Grandview Reserve Development – Engineering Review #2

We have received the submitted documents listed below on March 17, 2026, for the proposed Grandview Reserve development located at 1671 Grandview Drive in Alexandria, Kentucky.

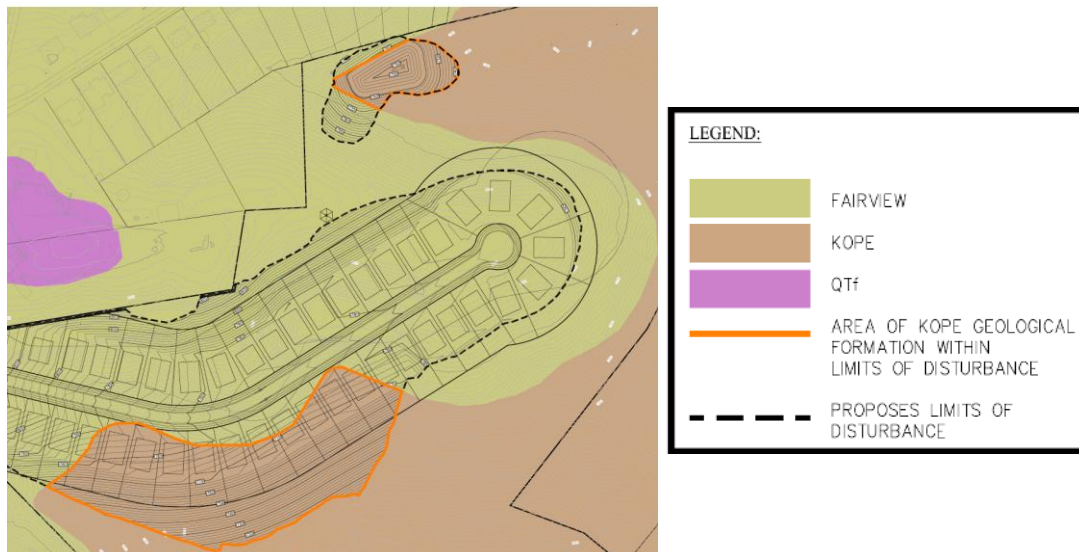
- ▶ The Engineering Review #1 letter indicated that the development site plans were to be amended to include the following items:
 - Identification of slopes 18% and greater;

- ▶ The Slope Analysis Exhibit show cross-sections that were cut every 20 feet along the alignment of the roadway using the lidar tin surface created from Cardinal Engineering's UAV and delineated all areas $\geq 18\%$ and $\geq 20\%$ in accordance with §3.28. Several areas of slopes greater than 18% were identified (27 out of 61 Cross-sections ~41%). Of these 27 cross-sections, only two contain slopes $\geq 20\%$ (Sections S-S & T-T).
 - Section S-S to Section W-W
 - Section Z-Z to Section J.1 – J.1
 - Section M.1 to Section O.1
 - Section Z.1 to Section B.2
 - Section E.2 to Section I.2

It was noted by Cardinal Engineering in their March 17, 2026, submission email that the roadway and lot grading have been aligned to avoid or minimize disturbance within these slope bands. Where disturbance of steep slopes is unavoidable, the grading is paired with engineered buttressing (keyways, benches, and controlled engineered fills) specified in the geotechnical report to improve overall stability relative to existing conditions.

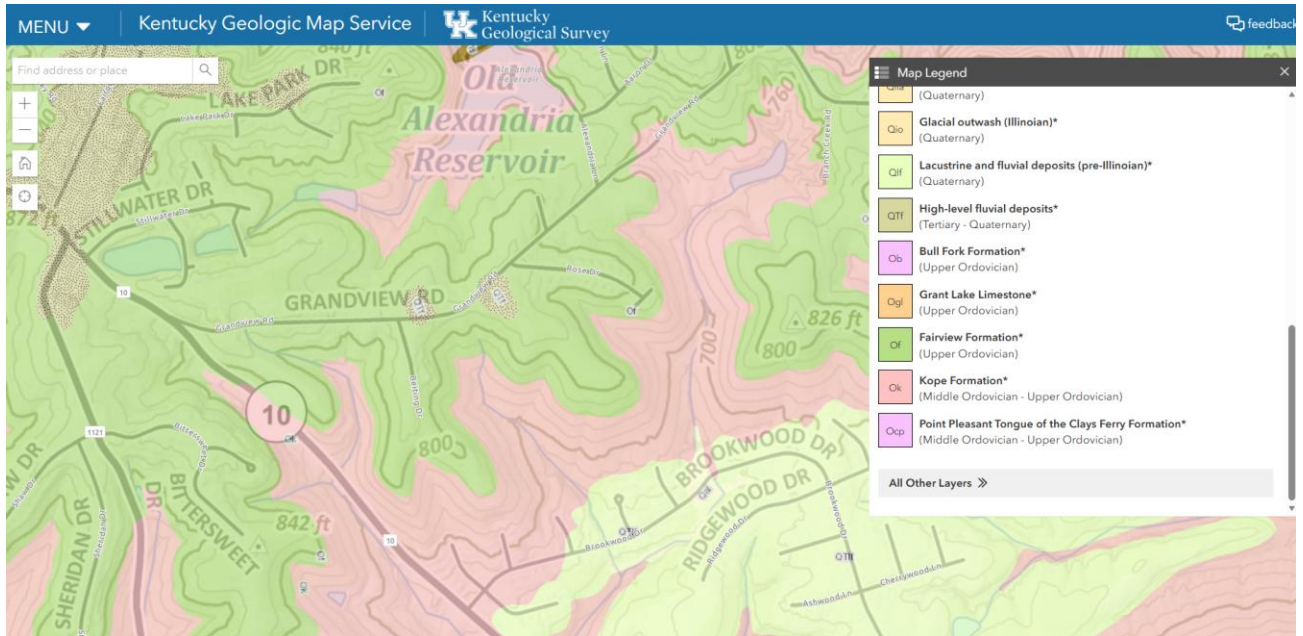
- Identify exposures of the Kope geological formation;
 - ▶ It was noted by Cardinal Engineering in their March 17, 2026, submission email that According to the Campbell County GIS geologic mapping, the mapped limits of the Kope Formation lie outside the areas where deep cuts or significant excavation are proposed within the residential portion of the development. Based on this mapping and the updated cut and fill analysis, It is not anticipated that any excavation into areas identified as Kope Formation, with the exception of the proposed detention basin. In the detention basin area, the grading design requires only a shallow cut of approximately 3.8 feet, and we believe the overlying soil thickness in this location is sufficient such that exposure of shale bedrock is not expected during typical construction activities. If any isolated shale seams are encountered, standard geotechnical measures will be implemented to ensure they are properly stabilized and not left exposed.

- ▶ According to the Kentucky Geological Survey interactive geologic map, The Kope Formation are located within the project site however it appears to follow along the 760' elevation contour, which generally lies outside areas of significant excavation for the housing development.
